# Validating C2M VEC and VEO Limits

**IEEE 802.3ck Task Force**

**April 21, 2021**

# COM Analysis on Lim Channel 1 and 4 – ASIC to Module

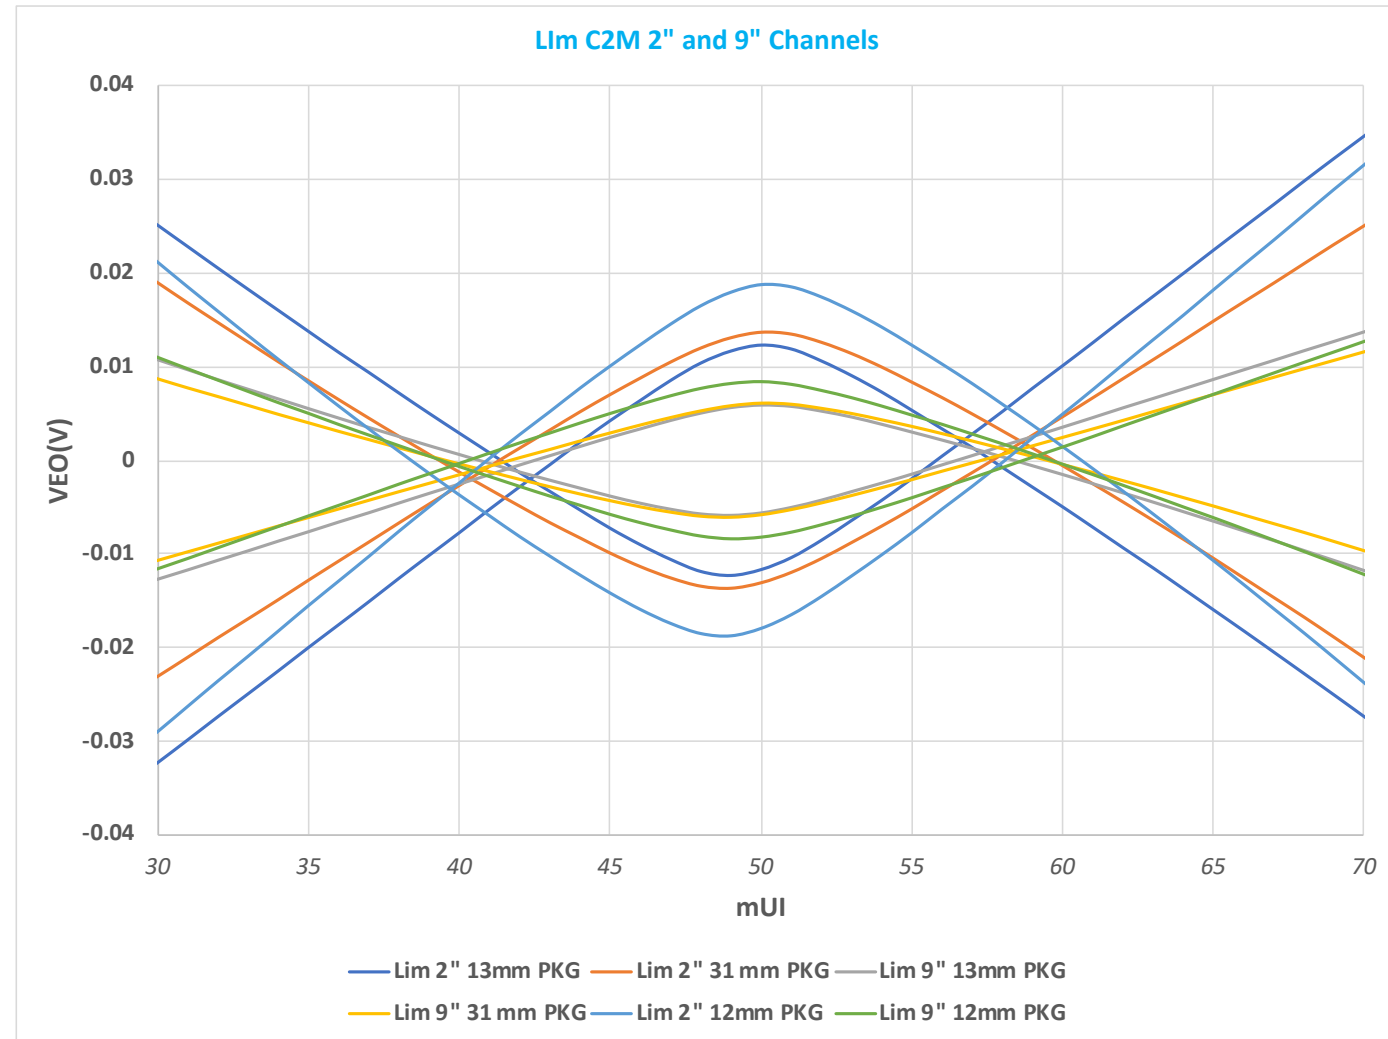
- ❑ **Lim channels include BGA footprint, via, host stripline, via, QSFP-DD connector and module module PCB**
  - Results for test case l=13 mm is pathological and consistent when timing window ts=0
  - VEO results with 50 mUI window are reduced by ~half and VEC increases by ~4 dB
- ❑ **VEO and VEC limits**
  - D1.3 window=0 mUI, VEO= 15 mV and VEC= 9 dB
  - D2.0 window +/- 50 mUI, VEO= 10 mV and VEC= 12 dB
- ❑ **VEO/VEC limits have become more difficult for host to pass with addition of timing window ts= +/- 50 mUI**
  - The VEO/VEC were to suppose to be adjusted for +/- 50 mUI window and limits have shifted the specifications!

# M2C Short and Long Channels

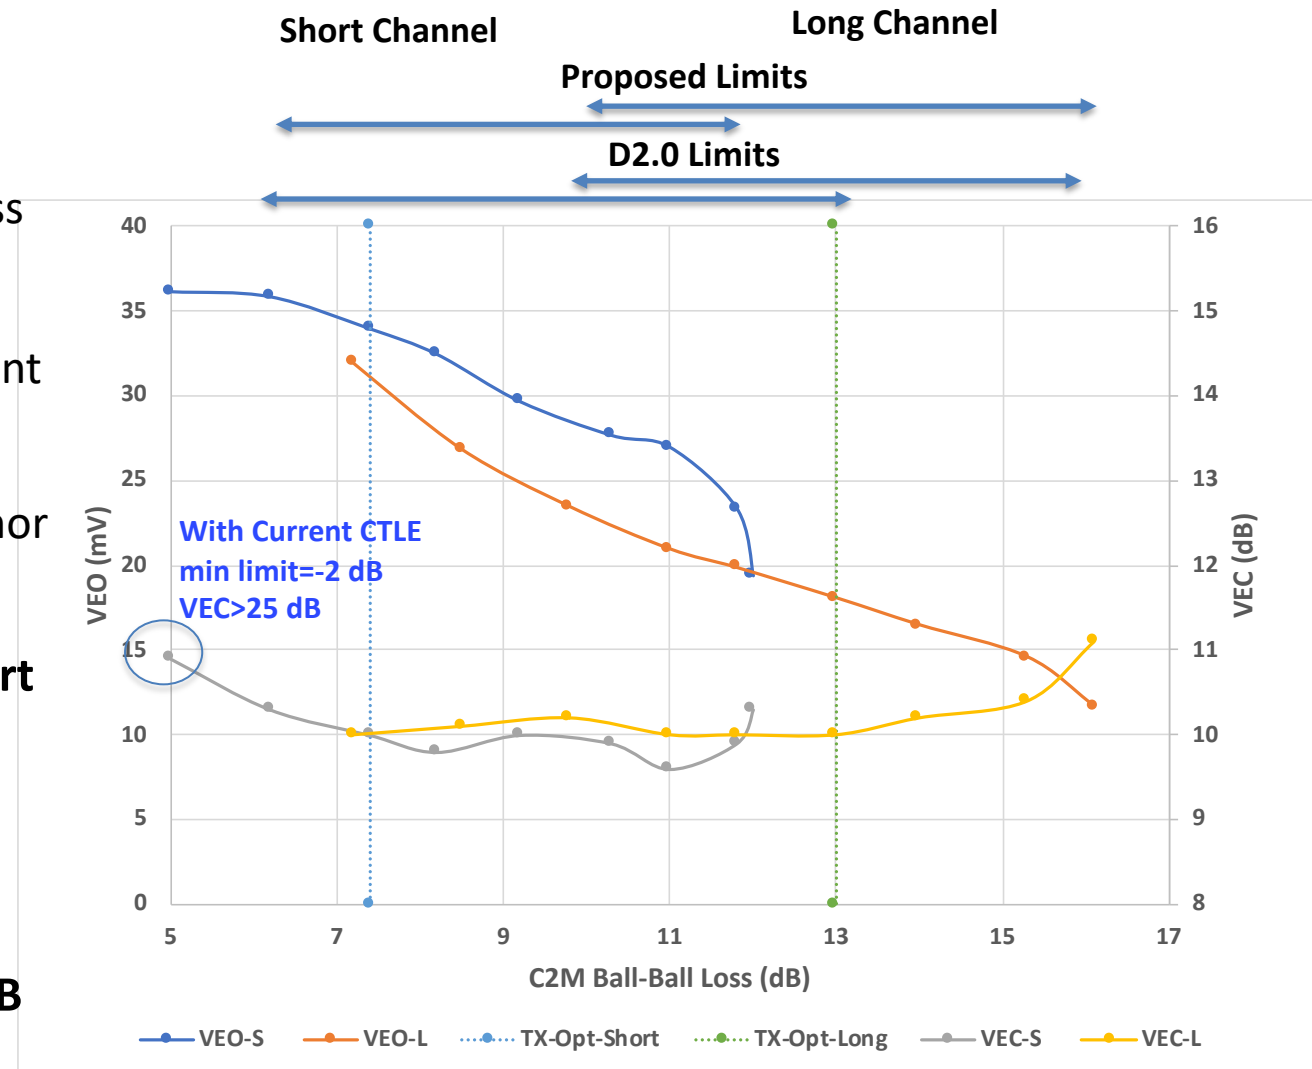
- Short 0 – 160 mm (6.6 dB) + MTF Loss
- Long 80 mm (3.1 dB) – 244.7 mm (9.6 dB) + MTF Loss
  - 9.6 dB + 6.6 dB MTF loss exceed max 16 dB
  - 244.7 mm should be reduced to 239.7 mm (9.4 dB)
- Short channel max loss up to 13.2 results in significant VEC/VEO degrading
  - Propose to reduce short channel max loss to 12 dB
- Not clear if MTF variations should be accounted or not with current procedure explicitly specifying added trace

## If one allow short range to go to as low as 5 dB VEC > 25 dB but this issue is avoided if one adjust for 1.6 dB MTF loss difference otherwise gDC need to be reduced from -2 dB to -1 dB.

- Assumes MTF loss of 6.6 dB
  - Short range will be from 6.6 – 11.8 dB (0 – 132.6 mm)
  - Long range will be from 9.7 – 16 dB (80 – 239.7 mm)
